## VOX Treble Booster

Modified to be used as an overdrive/distortion unit

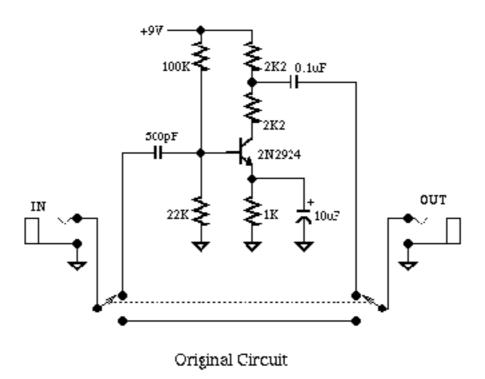
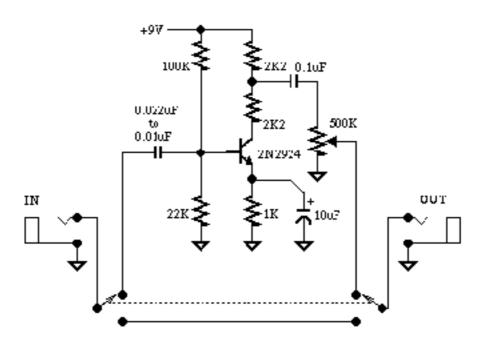
The input cap is changed from 50CpF to 0.01~uF (1000pF) or 0.022~uF (2200~pF) to allow more bass in. This usually overloads the booster and causes crunchy distortion.
